SCHWEIZER SERVICE NOTICE

NOTICE NO. N-190

SUBJECT: BUNGEE INSTALLATION KIT, PN M10123 - COLLECTIVE PITCH STICK

MODELS AFFECTED: Model 269A, TH-55A, 269A-1 and 269B Helicopters equipped with PN 269A1190-1 Main Rotor Blades

Figure 1. Bungee installation, Kit PN M10123 - Collective pitch stick

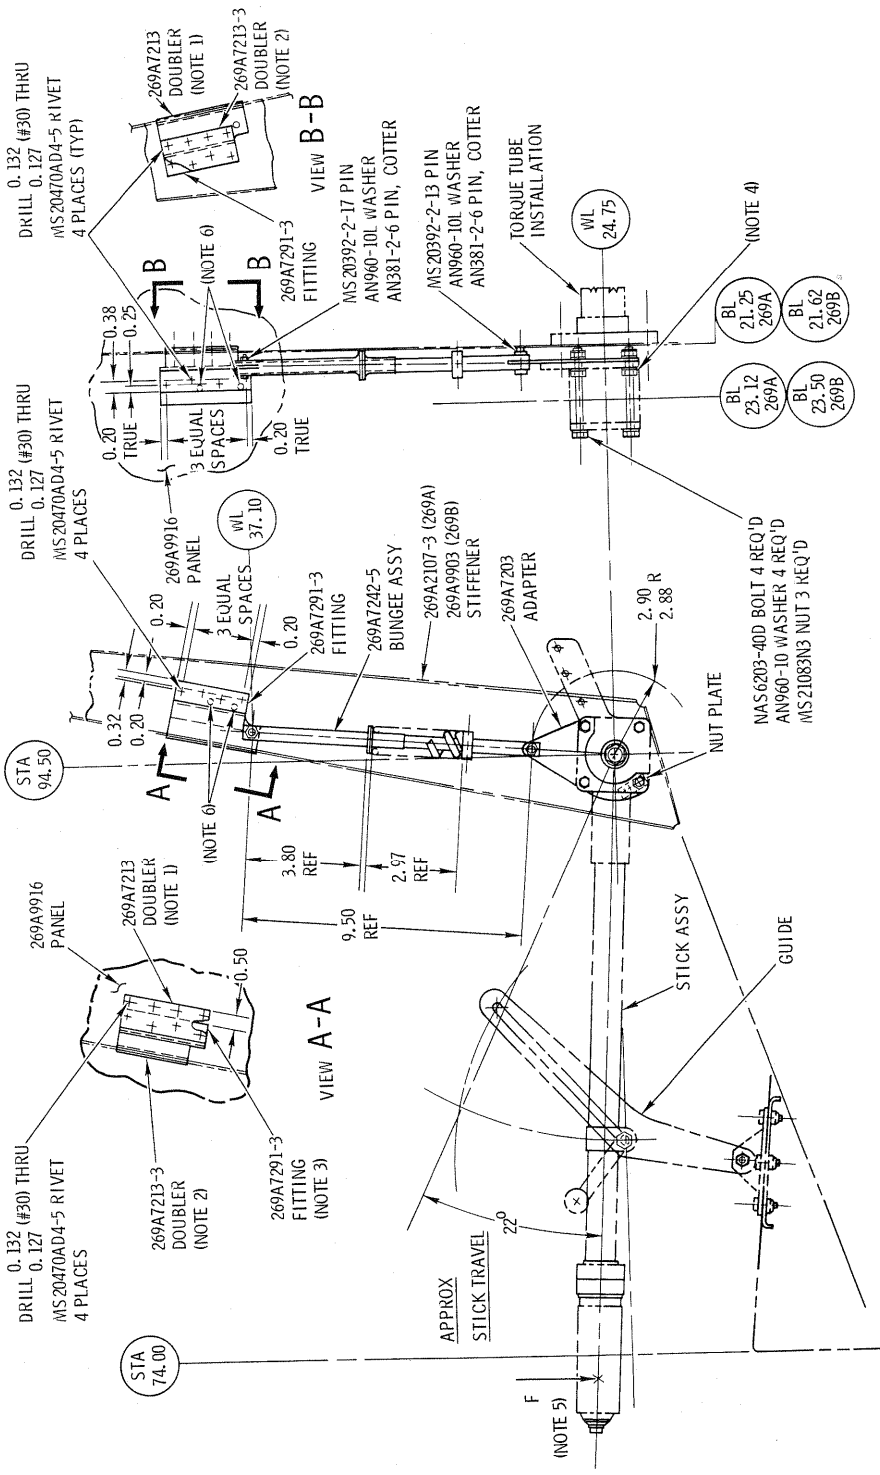
Rework per the kit installation instructions consists primarily of adding a new attach fitting with reinforcement doublers for the bungee upper end attachment, and a new adapter at the collective pitch stick housing for the bungee lower end attachment. Details are also provided for optional field fabrication of a special bungee spring compression tool, PN 269A7242-5-80901.

- b. Drill out rivets securing existing bungee attach fitting to stiffener and to aft side of fuselage seat back panel assembly.
- c. Remove bolts, washers and nuts (4 places) securing pitch control housing assembly. Install new PN 269A7203 adapter to housing with new bolts, washers and nuts (4 places) as shown. (See Figure 1.)

- d. Install new PN 269A7291-3 attach fitting, and new PN 269A7213 and PN 269A7213-3 doublers, to seat back panel and stiffener per dimensions shown in Figure 1. Install all rivets with zinc chromate primer.

- e. Install new PN 269A7242-5 bungee assembly; use special tool or equivalent to compress spring and install cotter pin. (See Figure 1.)
- f. Rig cyclic and collective controls, per Section 8 of Basic HMI; perform rigging flight check and adjust collective bungee as required.

- NOTES:**
1. INSTALL 269A7213 DOUBLER ON INTERIOR SIDE OF SEAT BACK PANEL.
 2. INSTALL 269A7213-3 DOUBLER ON INBOARD SIDE OF STIFFENER.
 3. INSTALL 269A7291-3 FITTING ON EXTERIOR SIDE OF SEAT BACK PANEL AND OUTBOARD SIDE OF STIFFENER.
 4. FOR BUNGEE INSTALLATION ON MODELS 269A & 269A-1 WHERE THE COPILOTS COLLECTIVE STICK ASSY IS NOT INSTALLED, THE SHORTER NAS6203-5D BOLT SHALL BE USED (4 PLACES).
 5. ESTIMATED HAND FORCE $F = 20LB$.
 6. OPEN HOLES PERMISSIBLE IN SEAT BACK & STIFFENER DUE TO DRILLED OUT RIVETS.

Figure 2. Field fabrication of collective control bungee tool, PN 269A7242-5-80901

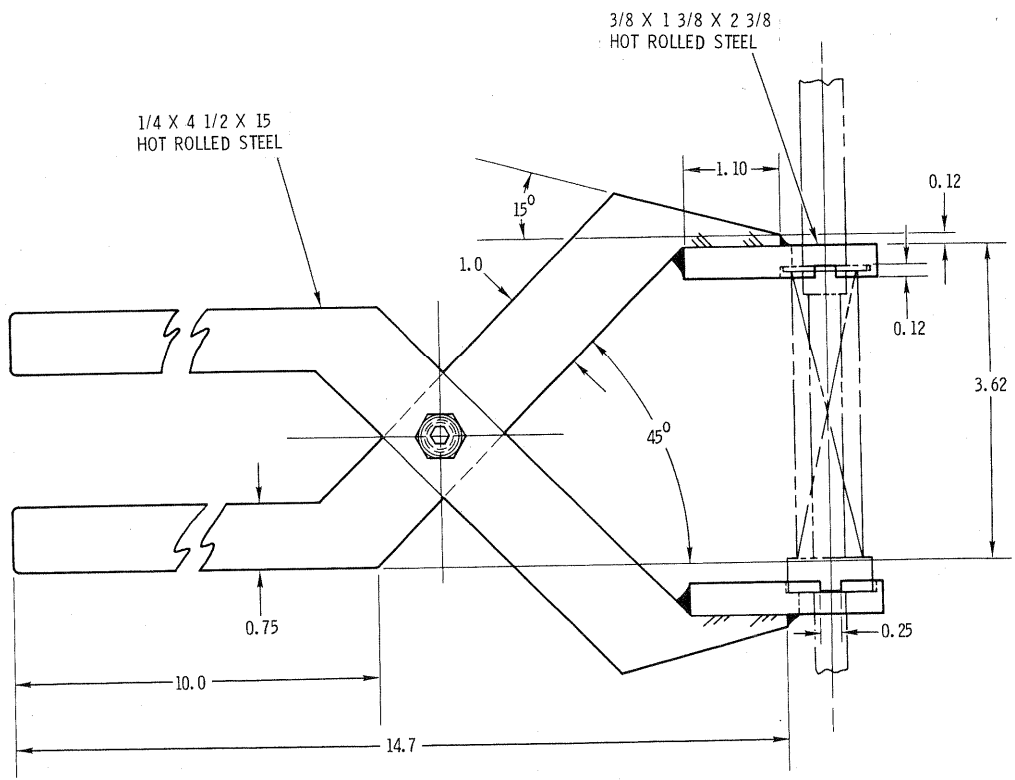
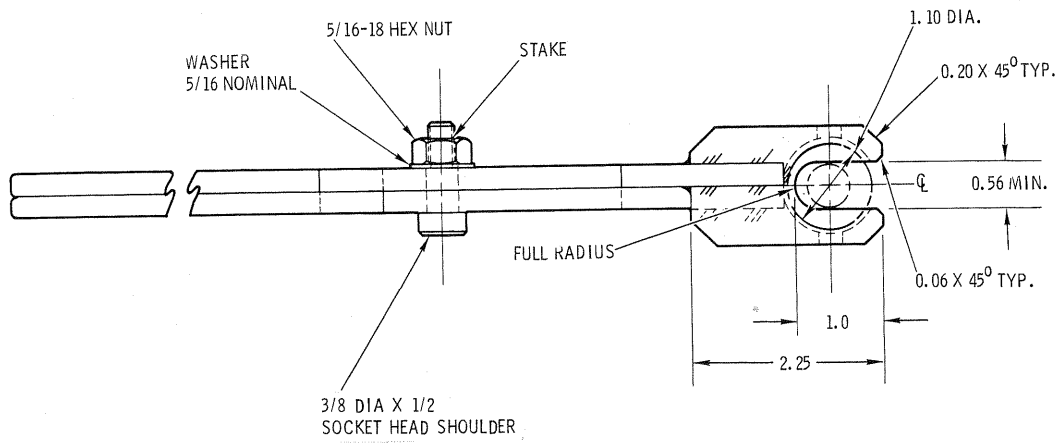
*May be field fabricated per details, Figure 2
